# HILLIARD PLANNING AND ZONING BOARD MEETING

TUESDAY, JUNE 13, 2023, 7:00 PM

**ITEM-2** Planning and Zoning Board Approval of Site Plan Application No. 20230119  
Oxford Pointe Multifamily Housing. Property Owner - Wayne Bishop  
Parcel ID No. 08-3N-2380-0063-0010.  
**Lee Anne Wollitz- Land Use Administrator**

# OXFORD POINTE

C6.1  
PROJECT NUMBER: 2022-105

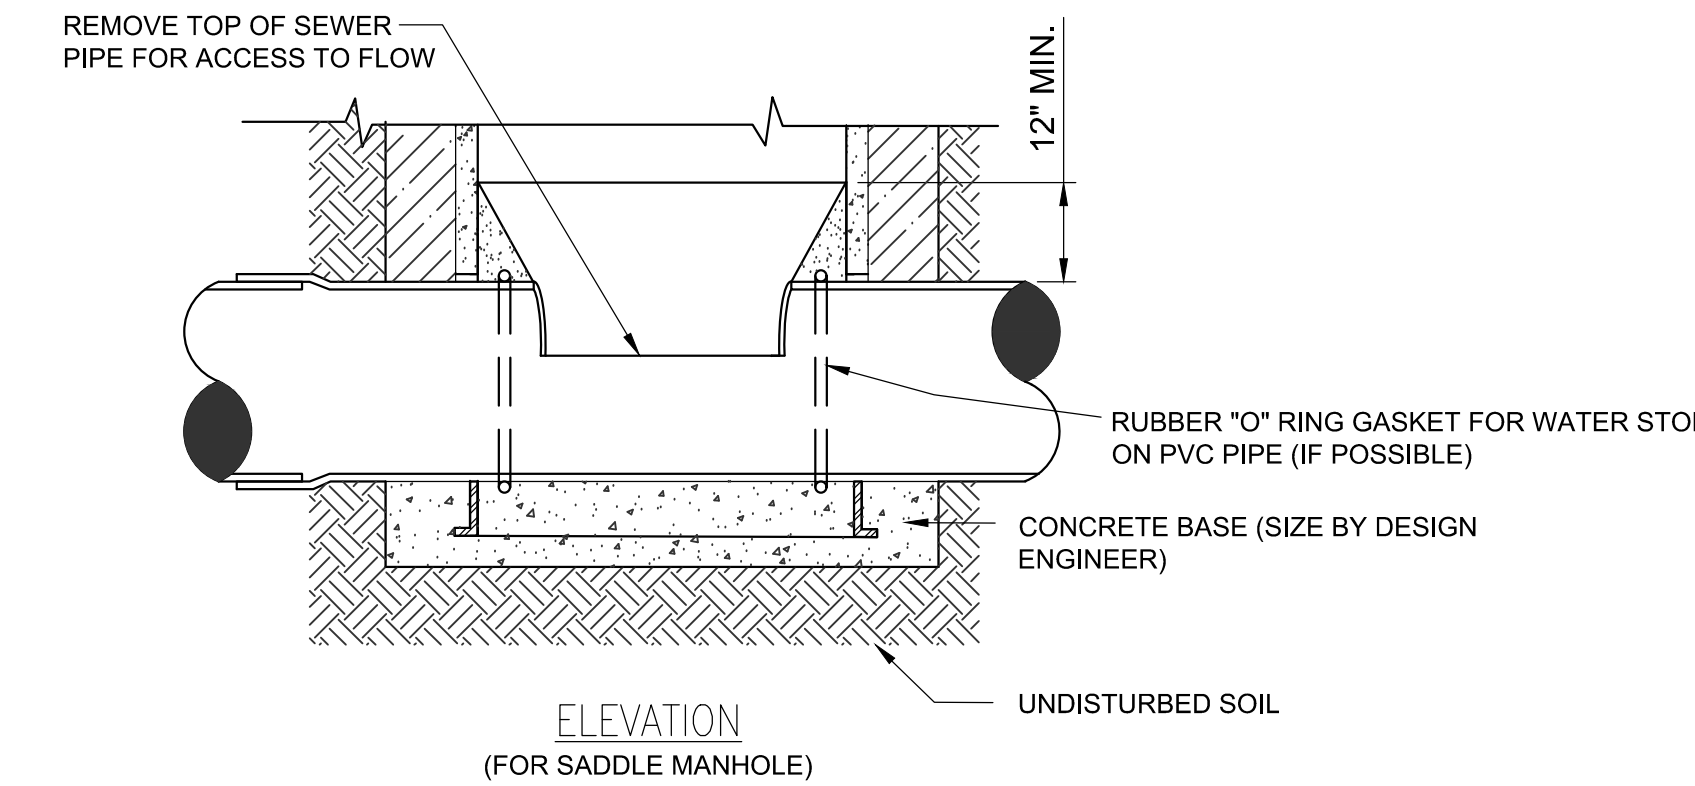
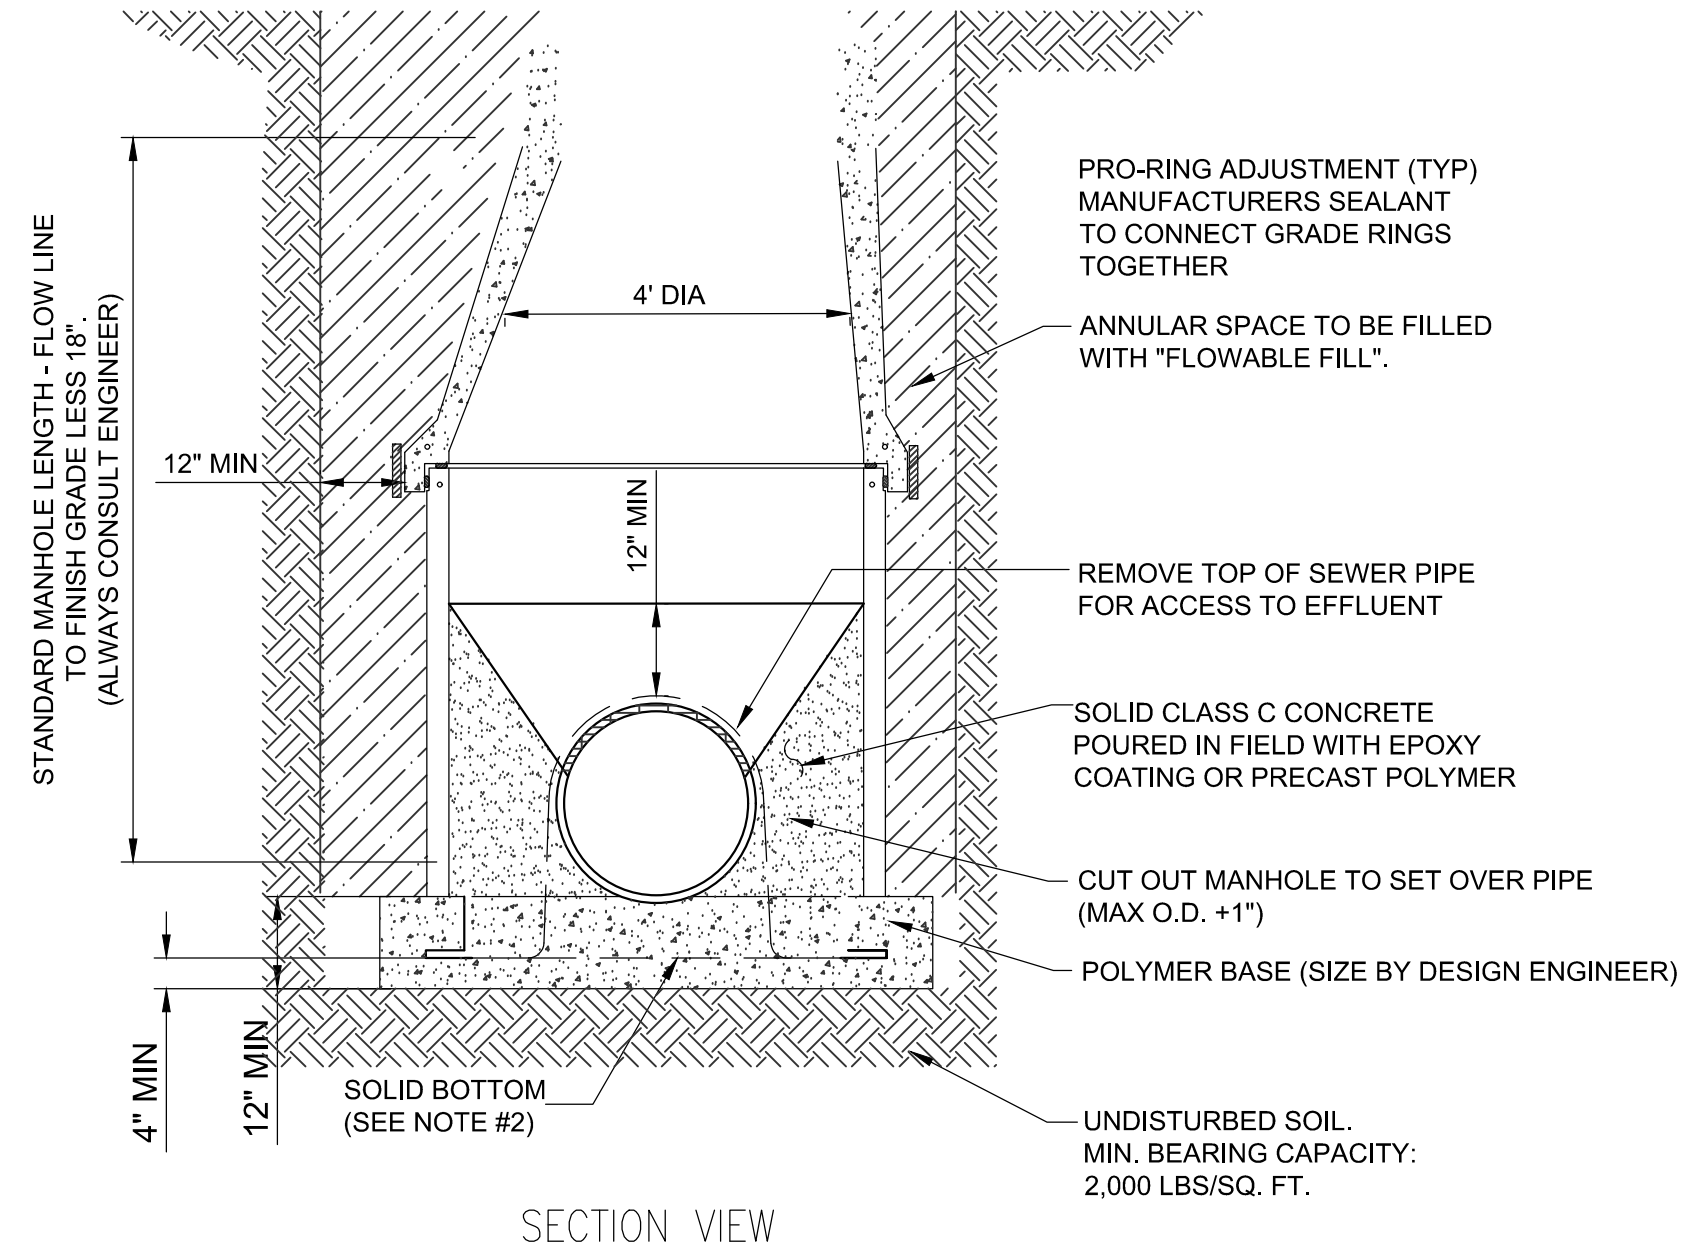
1. JEA Details are acceptable where the Town of Hilliard Details do not apply. Update details to include relevant information not presented in the Town of Hilliard Details. For example, add the previously provided Doghouse Manhole detail, add the previously provided Separation Requirements detail, add the previously provided PVC Pipe Restraint Joint Schedule detail, etc.  
**JEA details have been provided as requested.**
2. Add Town of Hilliard Trench Detail for unpaved areas (S-12/W-12).  
**Per the revised plans, detail W-12 has been provided which covers the same information regardless of use.**
3. Add Town of Hilliard Utility Conflict Type B detail.  
**Per the revised plans, detail W-10 has been provided which covers the same information regardless of use.**
